CITY OF CODY  
PLANNING, ZONING AND ADJUSTMENT BOARD  
TUESDAY, DECEMBER 10, 2013  
CITY HALL COUNCIL CHAMBERS @ 12:00 NOON

<b>MEETING DATE:</b>	DECEMBER 10, 2013	<b>TYPE OF ACTION NEEDED</b>	
<b>AGENDA ITEM:</b>		P&Z BOARD APPROVAL:	
<b>SUBJECT:</b>	PRELIMINARY PLAT OF J & K MAJOR SUBDIVISION— A 15-LOT SUBDIVISION. SUB 2013-06	RECOMMENDATION TO COUNCIL:	X
<b>PREPARED BY:</b>	TODD STOWELL, CITY PLANNER	DISCUSSION ONLY:

# PRELIMINARY PLAT

## FOR THE J. & K. MAJOR SUBDIVISION

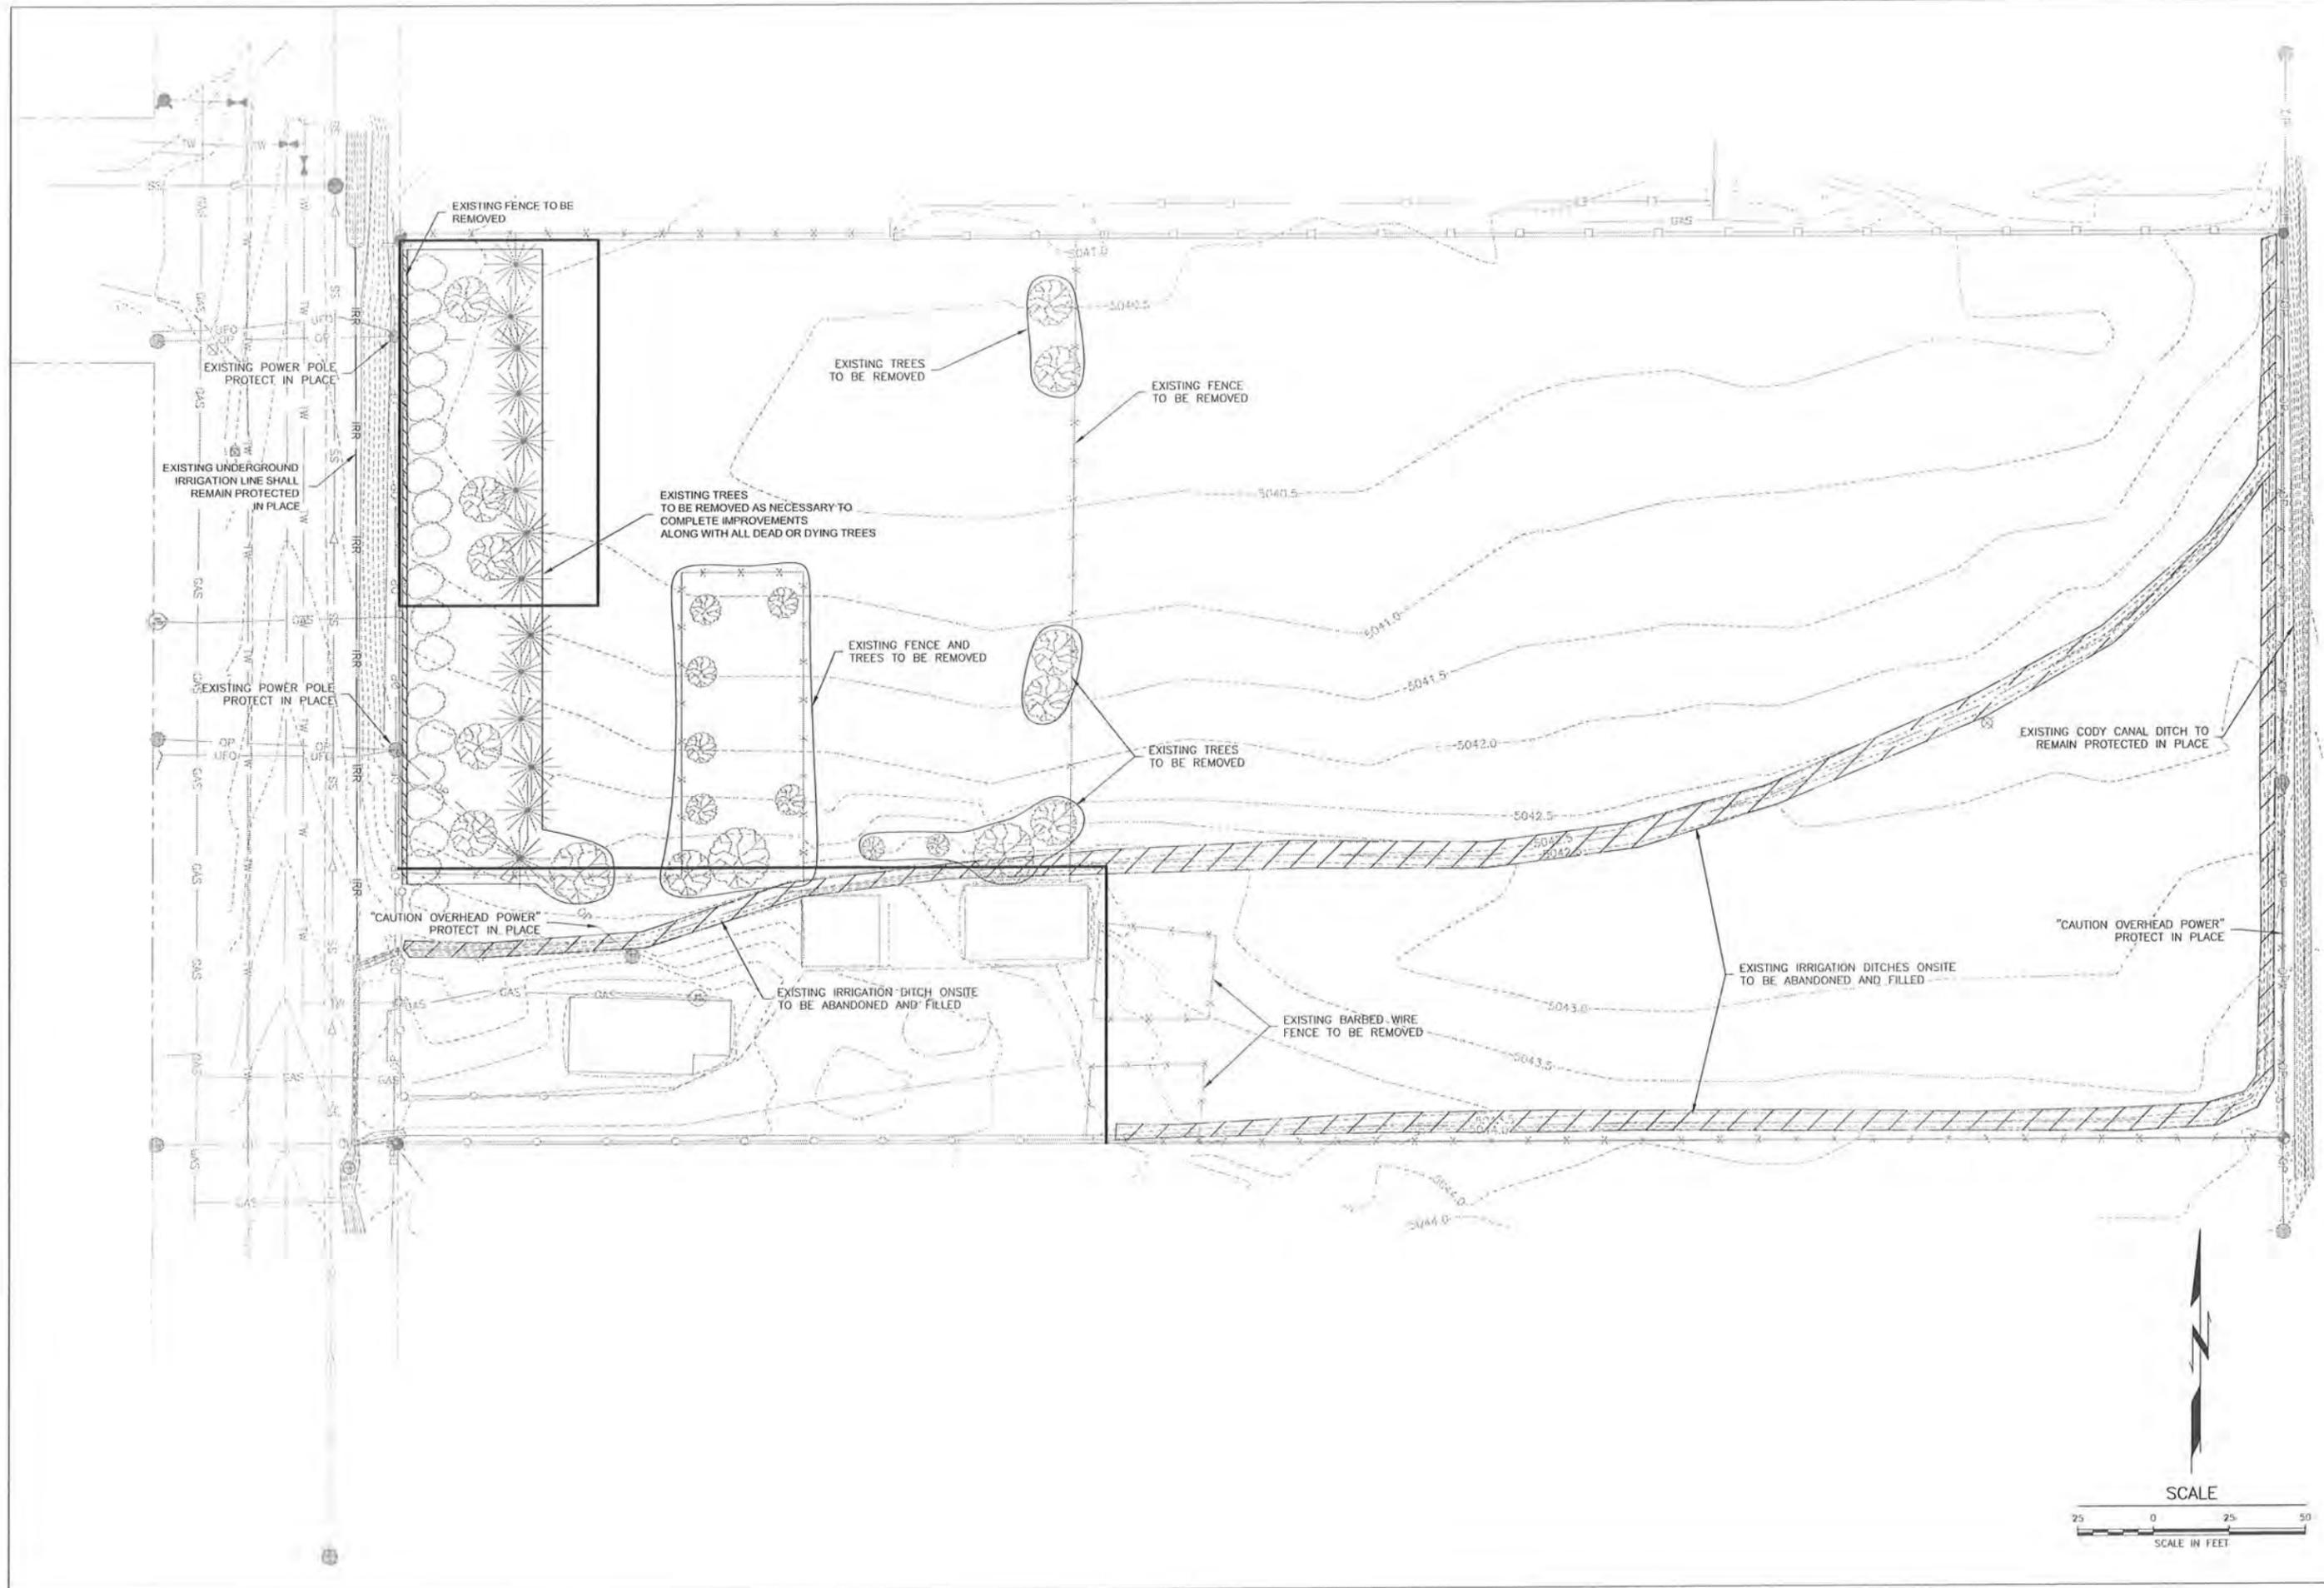
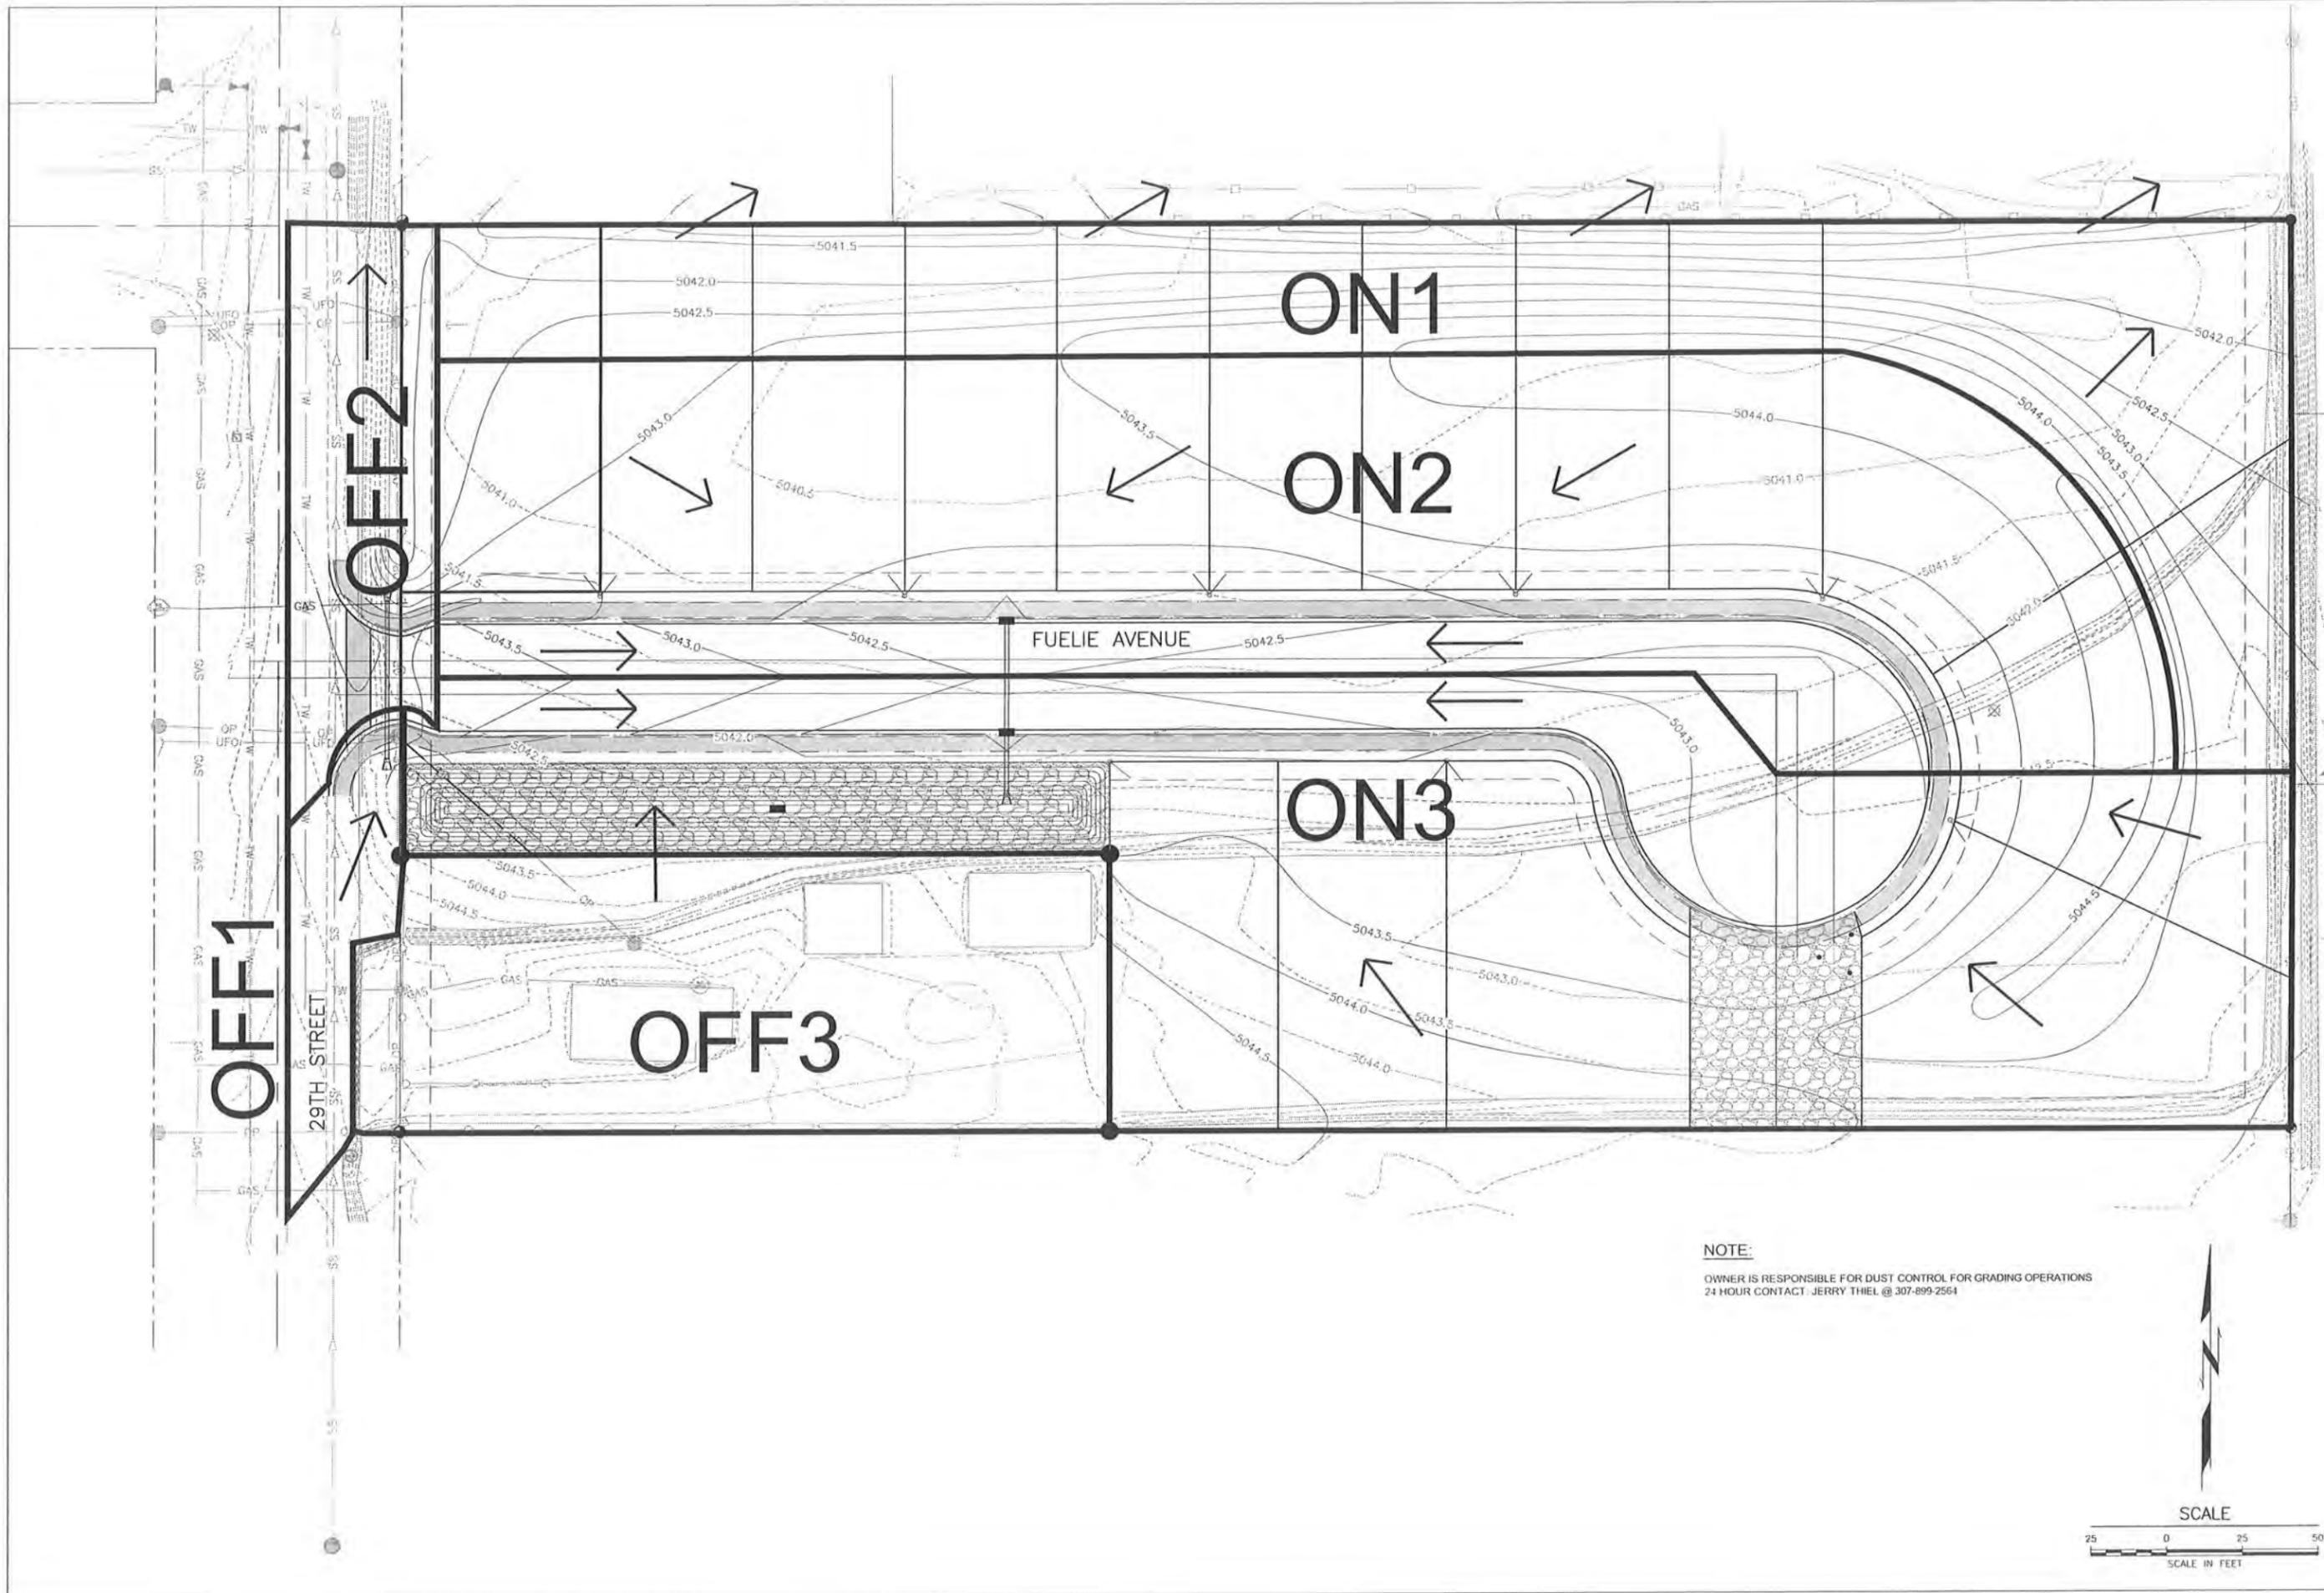
1. Make the following modifications to the preliminary plat, and provide a copy. The modifications are considered conditions of approval.  
Sheet 2: Update the variance language to reflect that above. Expand Note 2 to indicate the method of ownership of the tract and specify the construction details for lining the basin (2-inch minus cobble).

Sheet 2: Update the variance language to reflect that above. Add sidewalk along Lots 13, 14 and 15, with a ramp crossing at the west end and directly across the street (mid-block crossing). A detail of the ramps will be needed also. Change the label from "Open Space" to "Tract A" or similar and indicate by note the method of ownership and maintenance of the tract.

Response: Variances have been updated to variances listed. Sidewalk has been added throughout the subdivision eliminating this variance. A maintenance agreement will be setup with the homeowners to maintain the retention basin.
